TPB Ref.: A/HSK/621

Proposed Temporary Public Vehicle Park for Private Car for a Period of 3 Years at Lot 1898 RP in D.D. 124, Hung Shui Kiu, Yuen Long, N.T.

This letter intends to supersede our letter dated 29.7.2026.

Figure 1

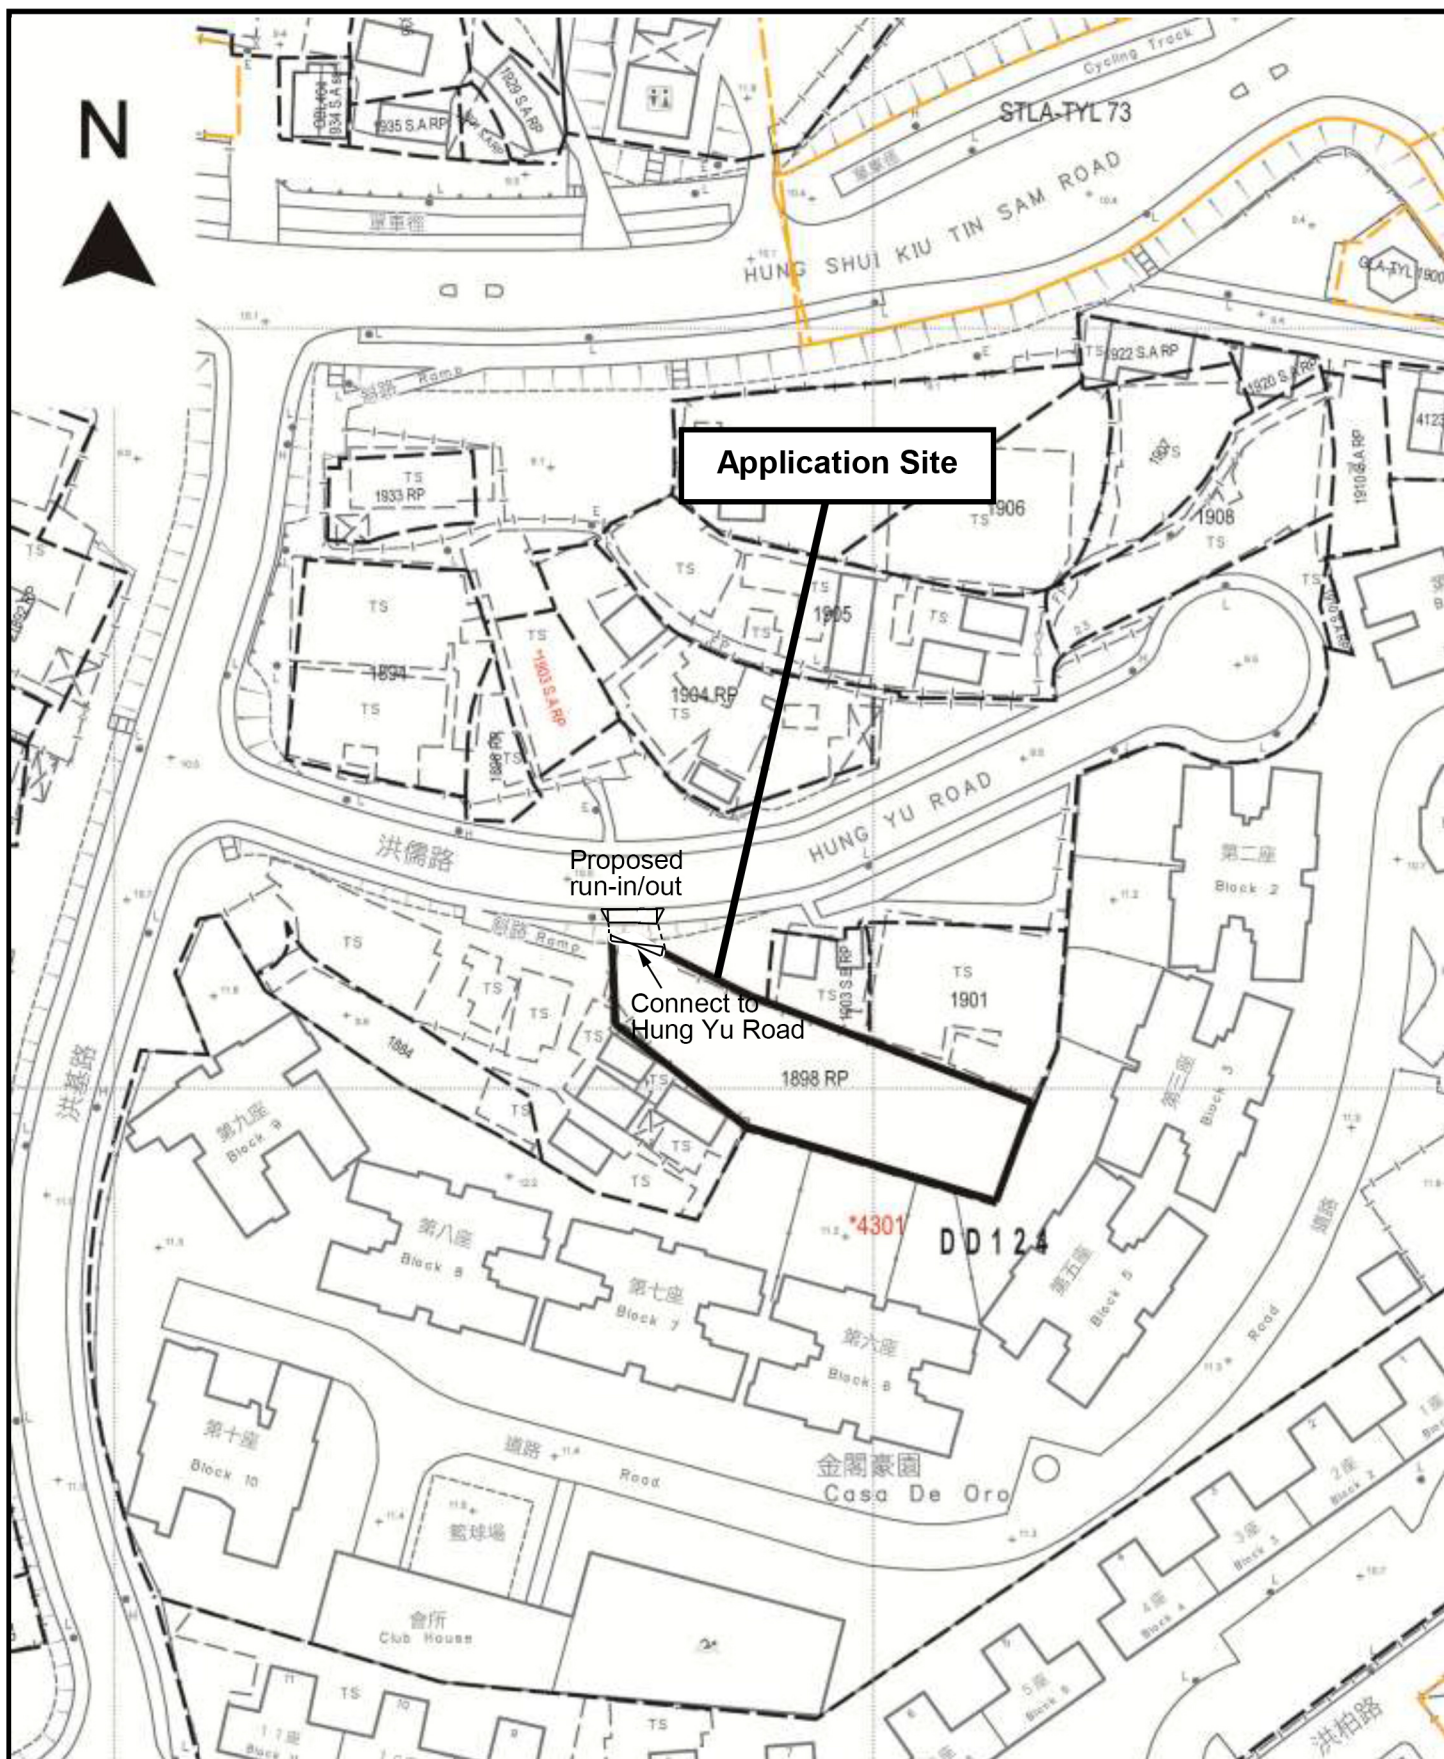
The proposed run-in/out is shown in the updated Figure 1. The applicant confirmed that no car beauty activity will be carried out at the captioned site.
